CITY OF ATASCADERO DESIGN REVIEW COMMITTEE AGENDA

**Committee Meeting
Wednesday, August 12, 2020
2:00 P.M.**

Cook Vertical Mixed-Use Project (DEV19-0124)

Staff Report – Community Development Department Vandeventer Commercial Park

Conceptual Landscape Plan (Front Portion of Property)

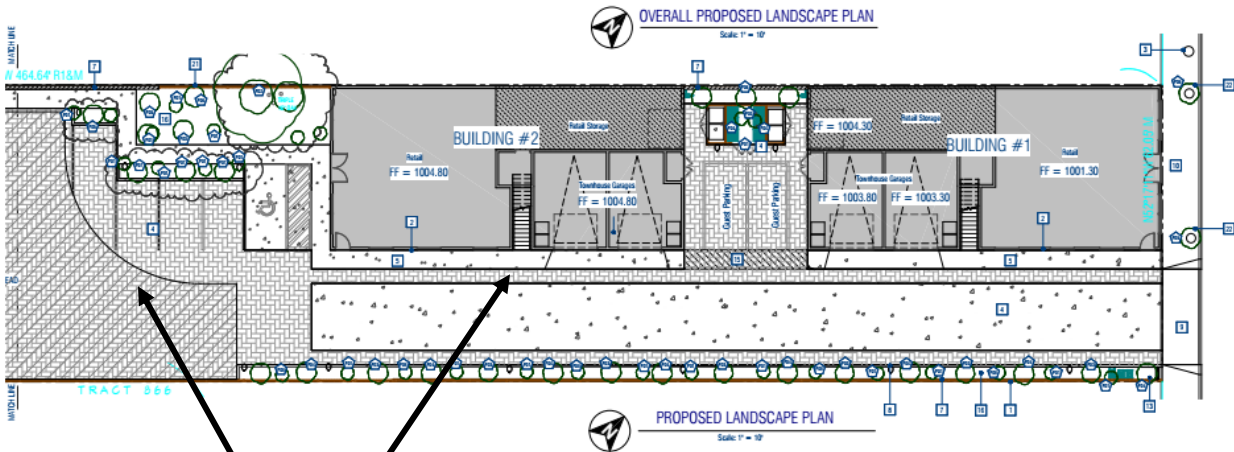
Staff is recommending additional small to medium sized trees be located throughout the site to accommodate additional landscaping and provide shade coverage. Installation of additional trees will increase landscape coverage in accessible areas of the site.

Building Elevations

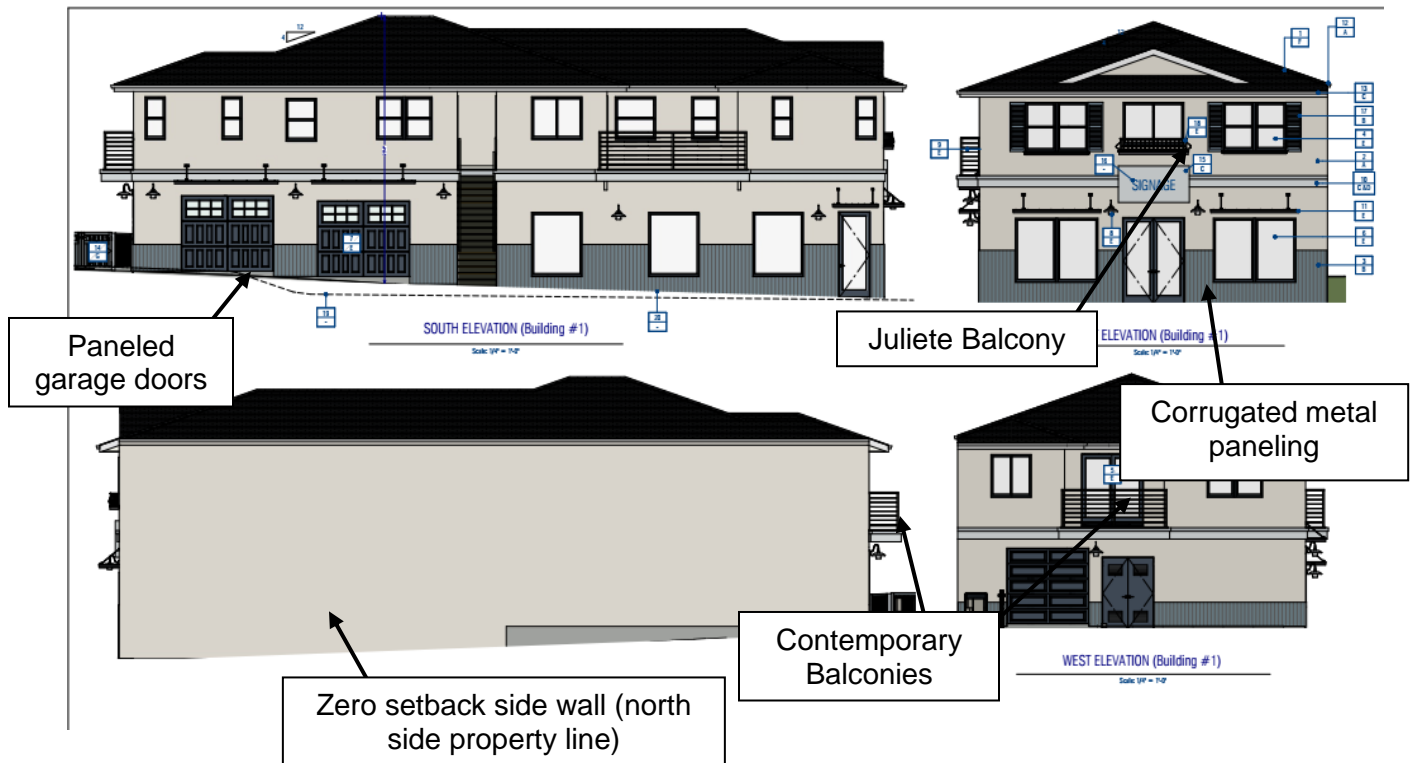
Staff is recommending the following architectural design changes for the project:

- **Darker building colors in order to allow for a color contrast with darker earth tone colors, preferably grey or brown.**
- **Increase the corrugated metal siding to midway on the buildings.**
- **Ensure that the shutters be proportional to windows.**
- **Consistent matching garage doors throughout the site.**
- **Consistent contemporary balconies throughout the site.**

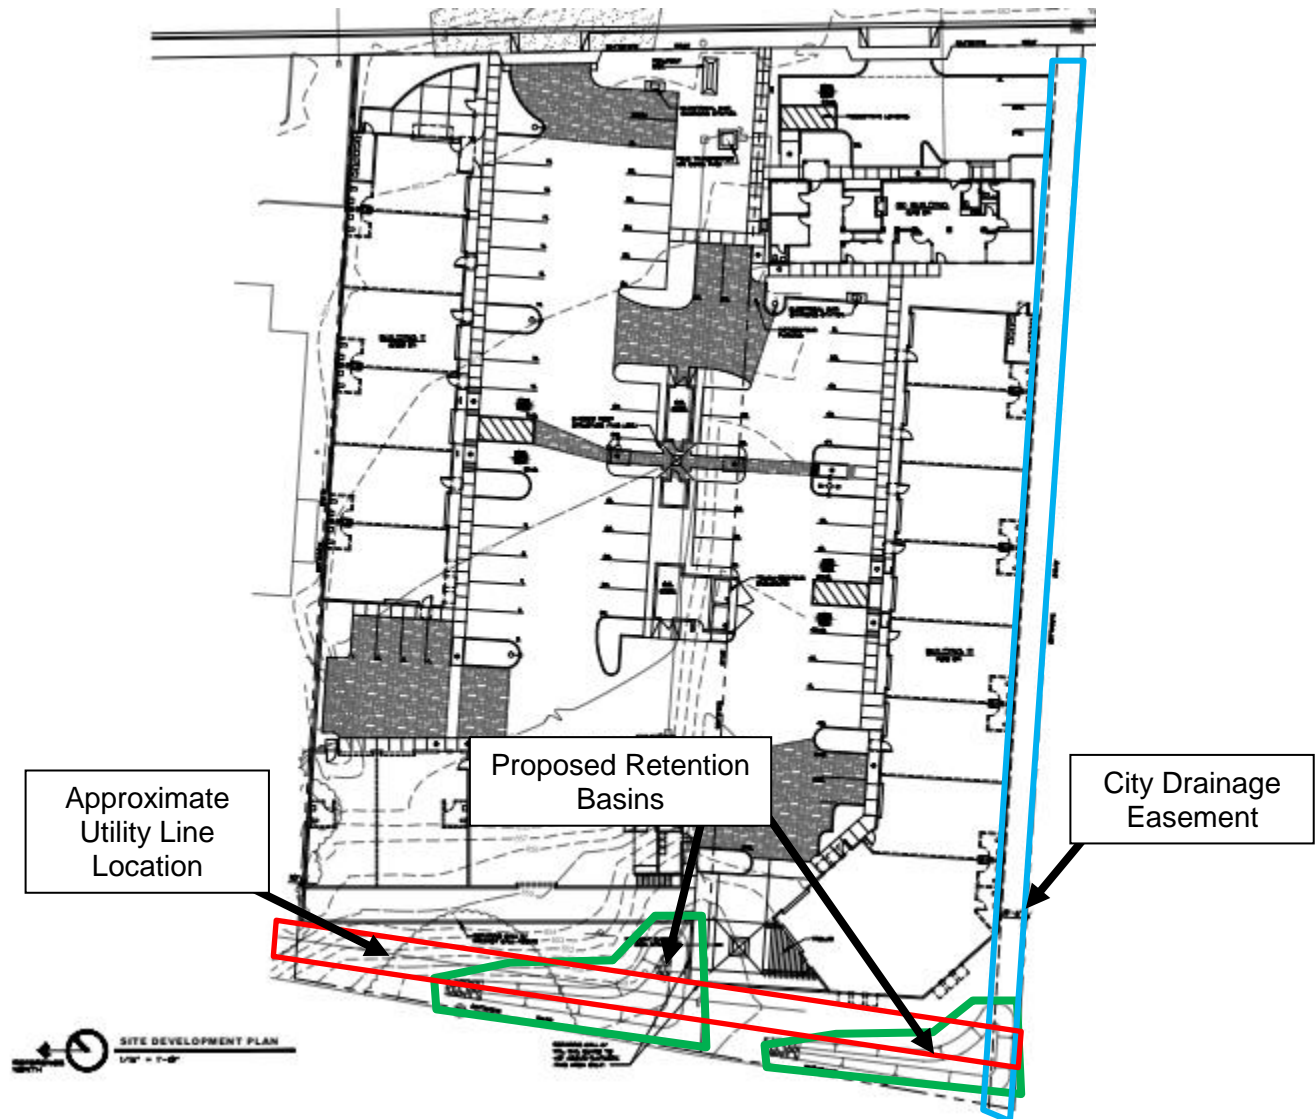
DRC does not review stormwater issues, but the retention basins may impact site design. The project site plans includes approximately 6,350 square feet of stormwater retention basins located under utility lines towards the rear of the property. These basins are

proposed to be sited under utility lines and also within a City of Atascadero drainage easement. The portion of the retention basin located within the drainage easement will need to be removed from the City easement. If the proposed basins under the utility lines are unable to be located within the existing easements or under utility poles, site design may need to change to accommodate the retention basins. Any substantial re-design of the site may need additional review by the DRC.

Staff is recommending that the applicant clarify the location of the detention basins within any easements and verify whether these are allowed to be located within easements before finalizing construction documents. Staff will add a correction to the site plan that the portions of the retention basin that is located within the City drainage easement be removed and that utility easement language be provided.

1. Relocate the basin outside the city easement.
2. Obtain and provide written permission from the utility easement holder(s) to place stormwater facilities and retention basin within the easement area (under utility lines).

Conceptual El Camino Real Monument Sign

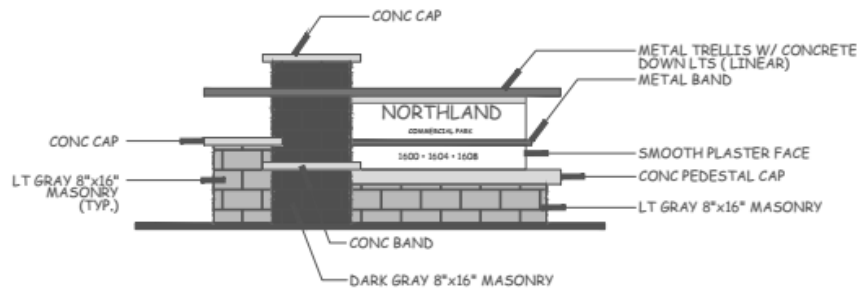
Staff is recommending the DRC comment on the proposed sign request and make a determination whether the site warrants this type of sign or whether signs on the buildings would be more appropriate. If the DRC believes this may be an appropriate option, the applicant will still need to apply for a separate signage permit exception (Administrative Use Permit) to allow for a multi-tenant freestanding sign beyond the allowed height in the AMC.

3. If multitenant free-standing sign is considered to be appropriate, apply for a separate signage permit exception to allow for a multi-tenant freestanding sign beyond the allowed height in the AMC.

North Wall/Building 2 Profile - Proposed Wall (CMU Fence) and Retaining Wall

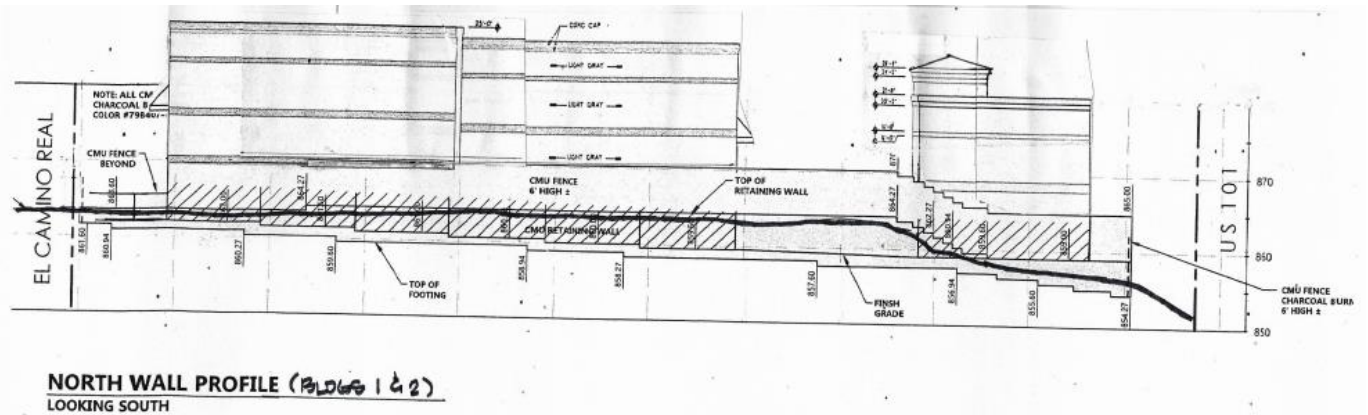
If the combined height of the retaining wall and screening wall is over six feet from the lowest point of the property line grade, staff is recommending that the retaining wall be stepped in order to avoid height allowance exceedance for the proposed screening (wall). A minor conditional use permit approval is required where fencing is proposed to be greater than six (6) feet in height within or outside any required setback.

Staff is proposing that the perimeter wall be no greater than six (6) feet in height as required by AMC code. In sections of the project along the property line where no buildings are proposed, staff is recommending a 6-foot wrought iron fence, except along the south property line where a solid wall is required to shield adjacent

4. Submit photometric light plan prior to permit issuance.
5. Perimeter wall shall be no greater than six (6) feet in height as required by AMC code. A minor conditional use permit approval may be required where fencing is proposed to be greater than six (6) feet in height within or outside any required setback.

West Wall/Building 1 and 3 Profile - Proposed Wall (CMU Fence) and Retaining Wall

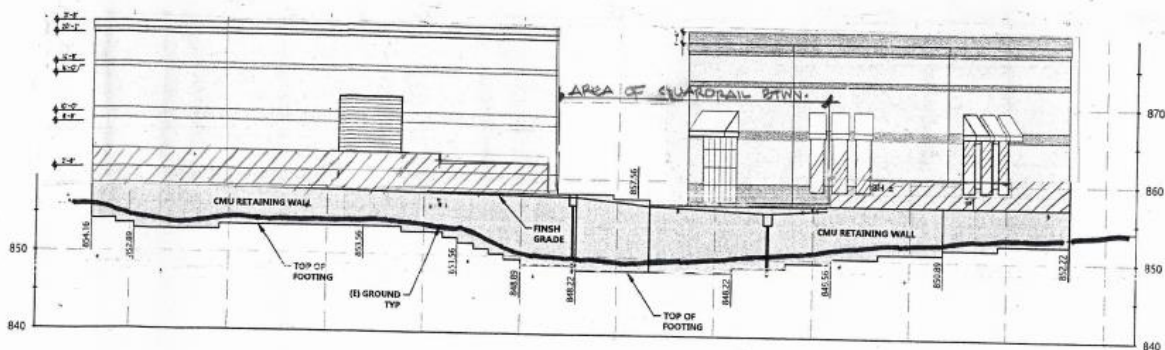
residential uses. Staff is recommending that as project phases are built, a wrought iron barrier fence be placed along the perimeter wall where appropriate and be removed as buildings are constructed. Additionally, the retaining wall adjacent to the City easement must be designed to keep footings outside of the City easement splay line.

Staff is proposing the wall be scaled down to meet AMC code section heights or that the retaining wall be stepped in order to avoid height allowance exceedance for the proposed screening (wall). If the wall is stepped, it would require that a second wall be constructed at least 5 feet away from the first wall, with a landscape area between the walls. With stepped wall construction, the overall perception of wall height can be visually reduced, however the cost of the wall and amount of space required for construction would be increased.

7. Retaining wall adjacent to the City easement shall be designed to keep footings outside of the City utility easement splay line.
8. If proposed perimeter wall and retaining wall on the south and north property lines exceed six (6) feet as allowed by the AMC, staff recommends that the wall be stepped. If the wall is stepped, it would require that a second wall be
